4328 Brooklyn Ave NE

Recommendation Meeting

SDCI: 3036008-LU

February 28, 2022

Appendix: Priorities & Board Recommendations -Massing & Materials (east facade)

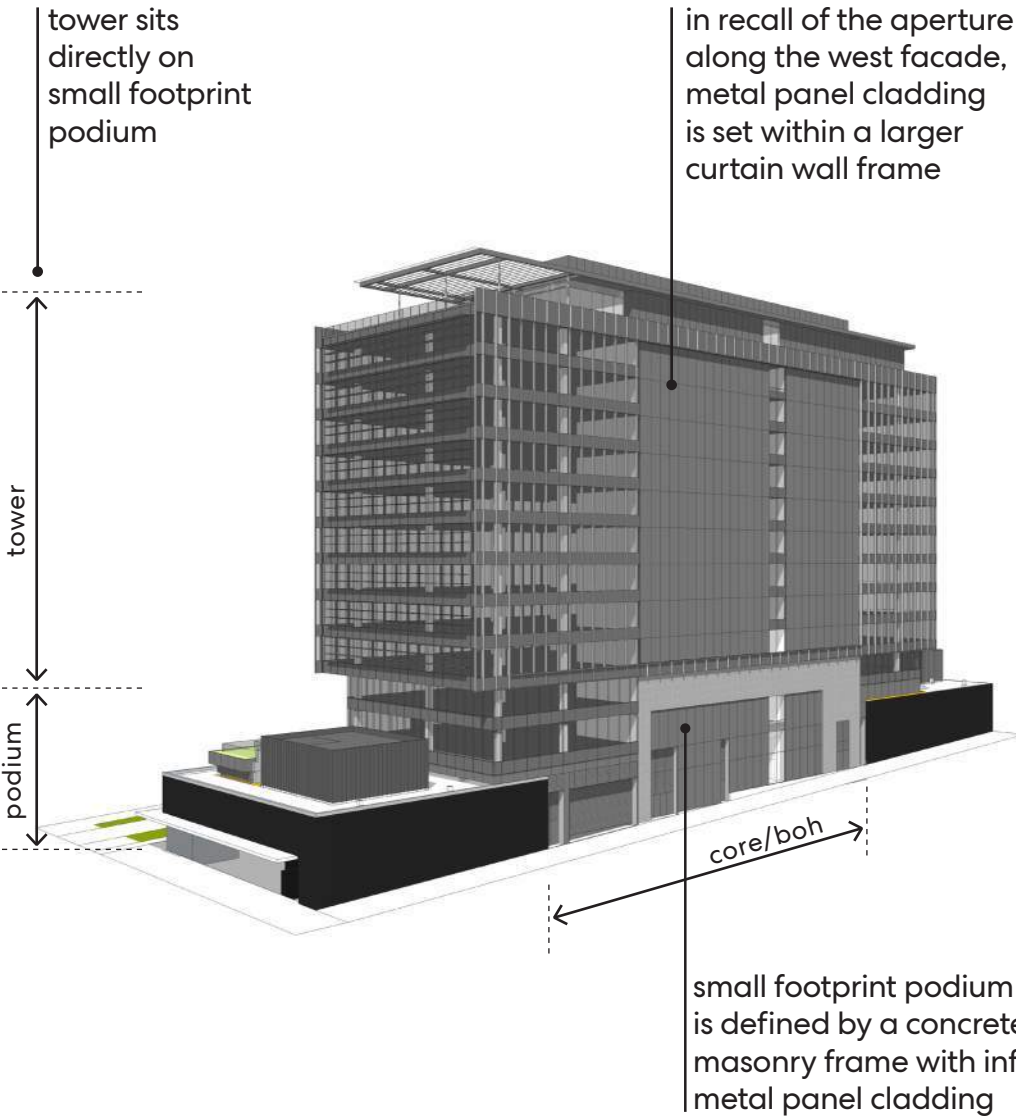
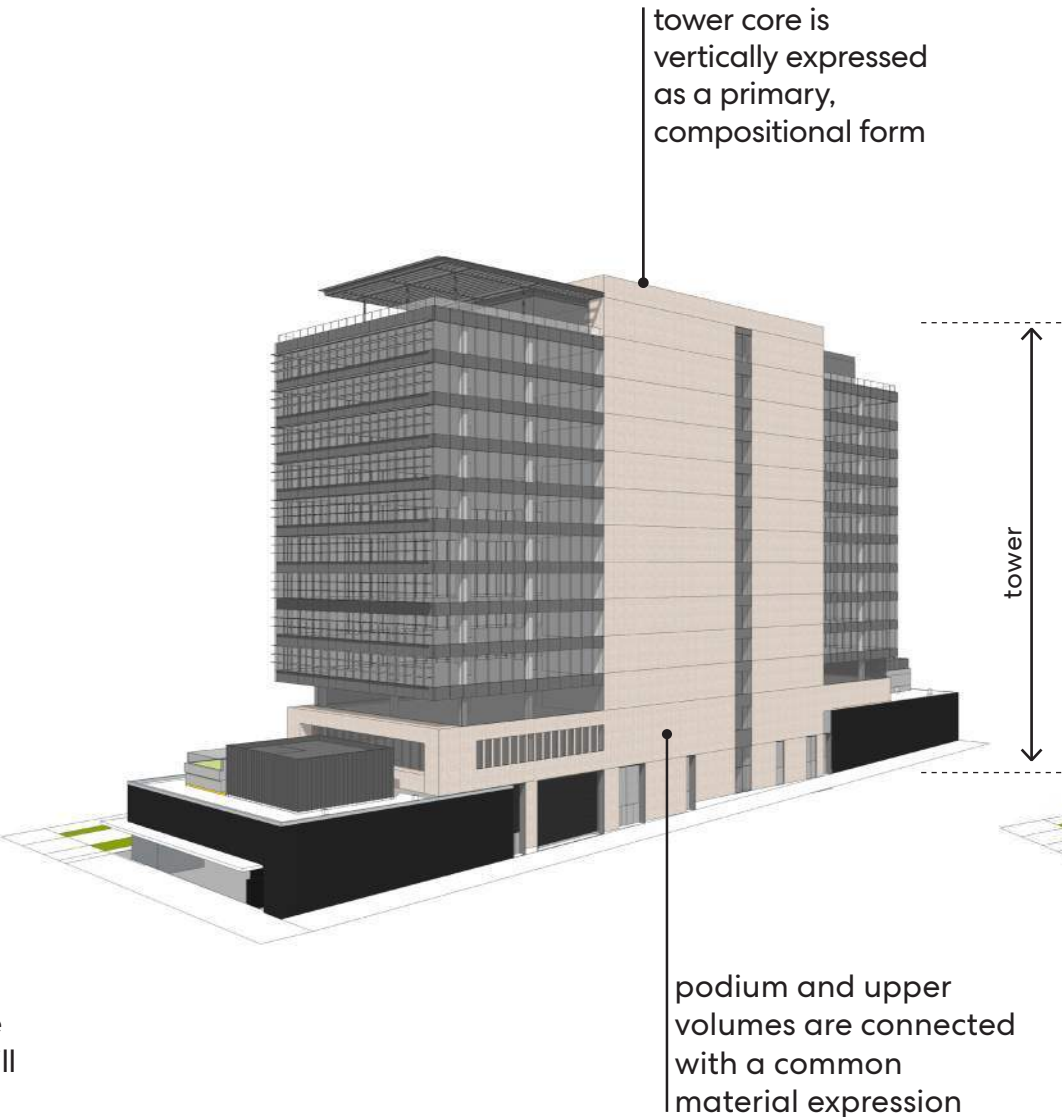
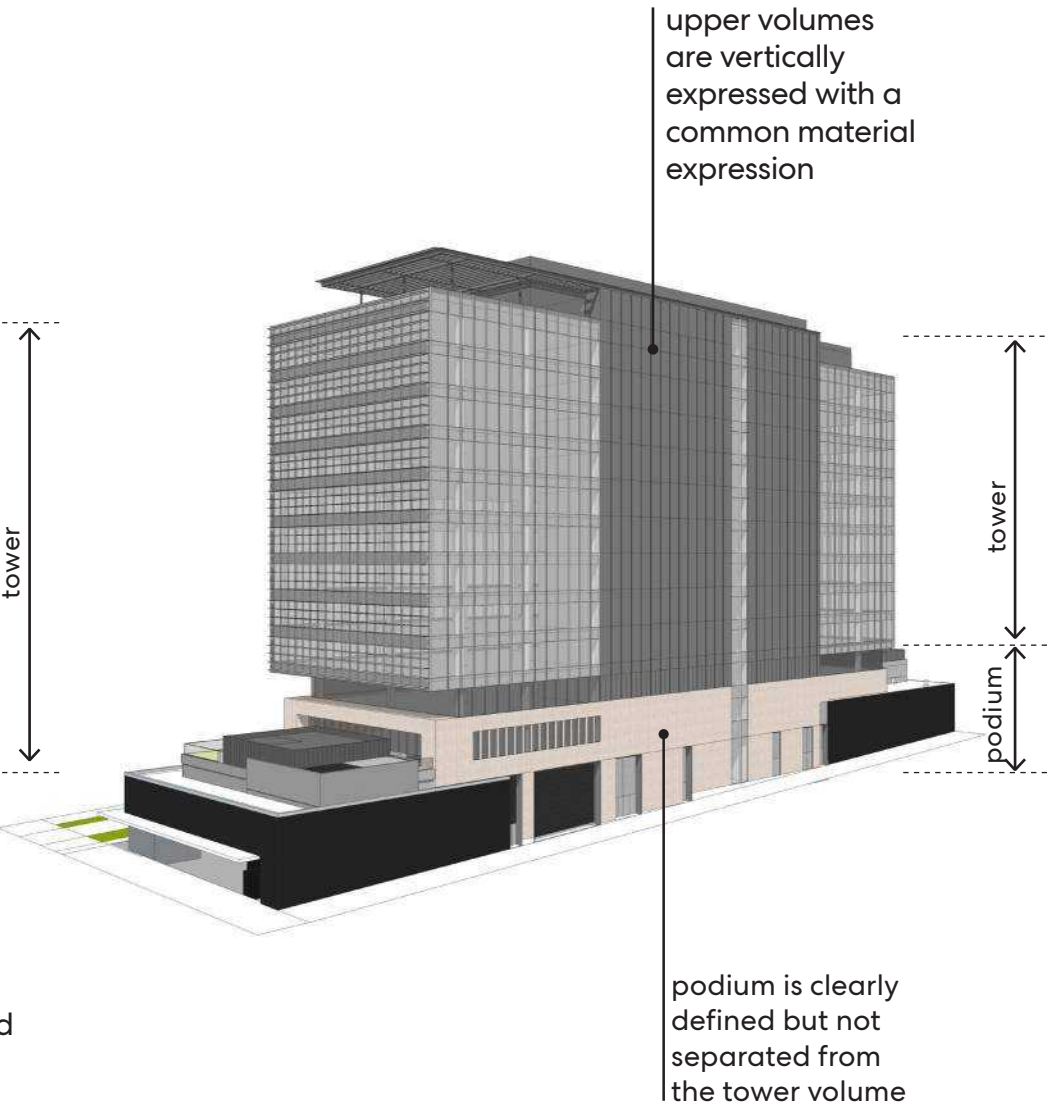
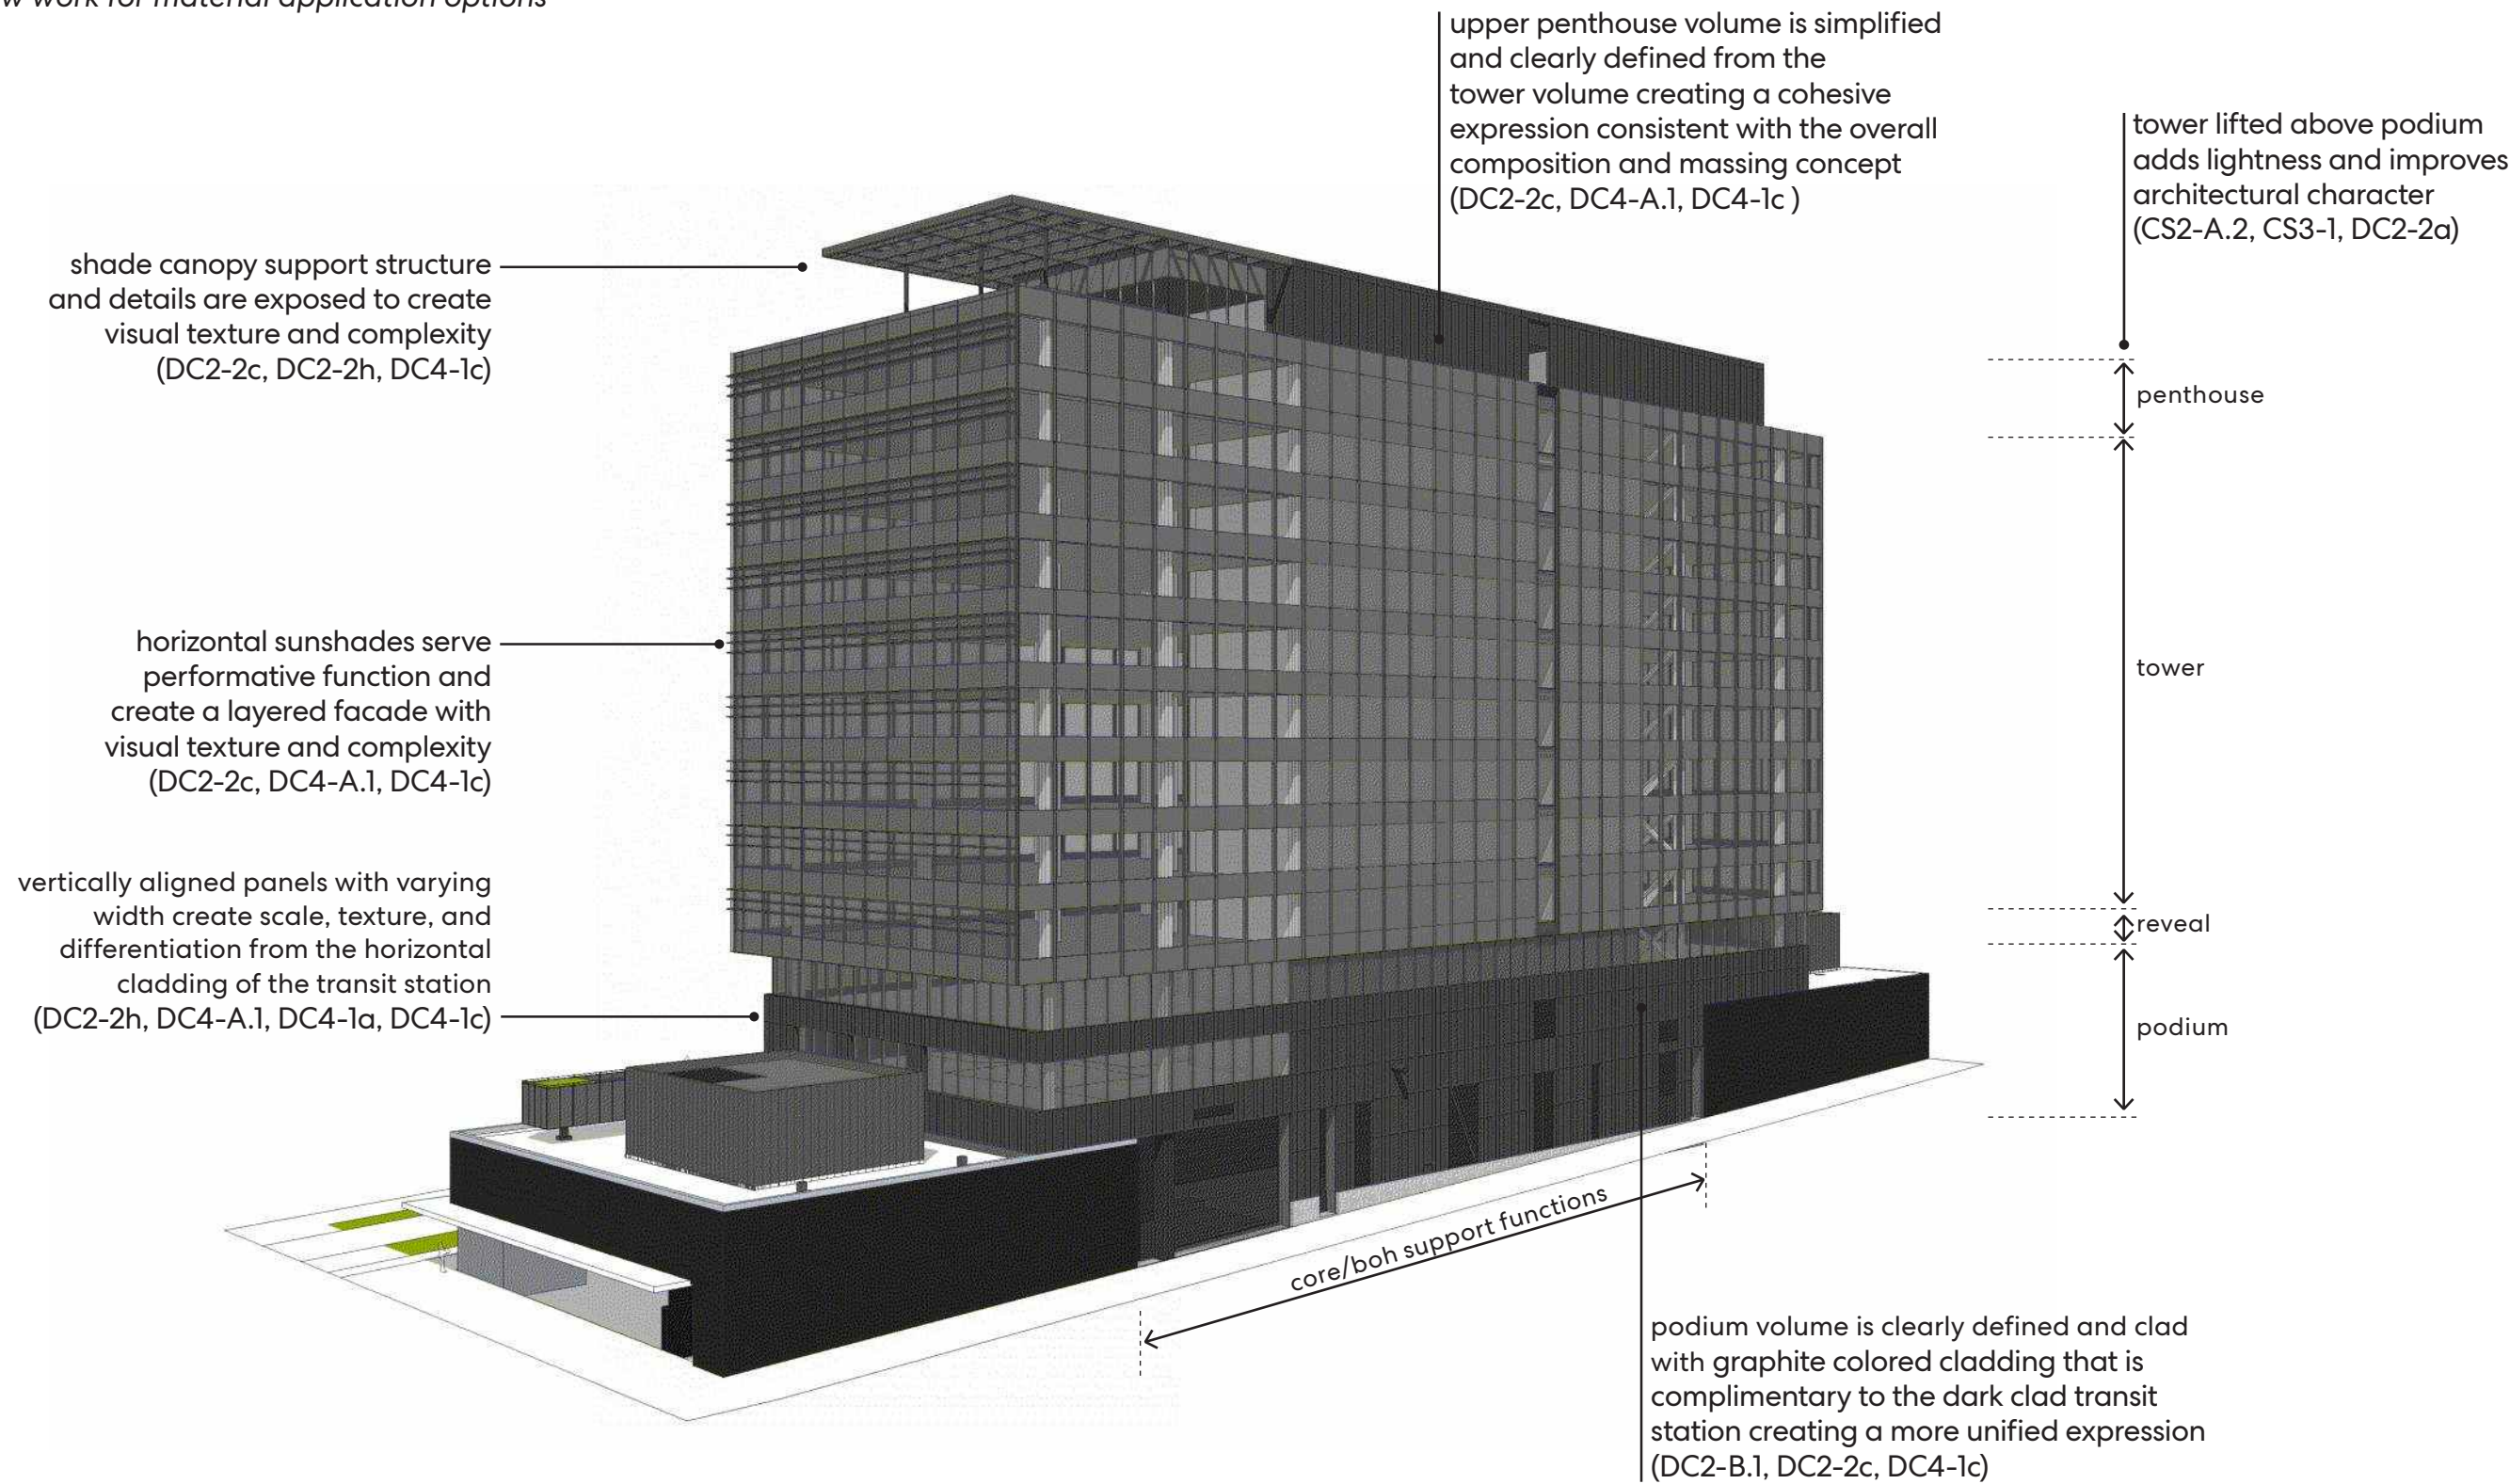
1c) Show work for material application options

Due to the existing below-grade transit tunnel along the west half of the site, it was necessary to locate all of the tower’s vertical circulation and support functions to the east along the alley. The design team explored a number of alternatives for resolving the blank facade areas inherent with a side-core configuration into a clear and legible composition with a cohesive architectural expression (CS2-A.2, PL3-1a, DC2-B.1, DC2-D.2, DC2-2c, DC4-1c)
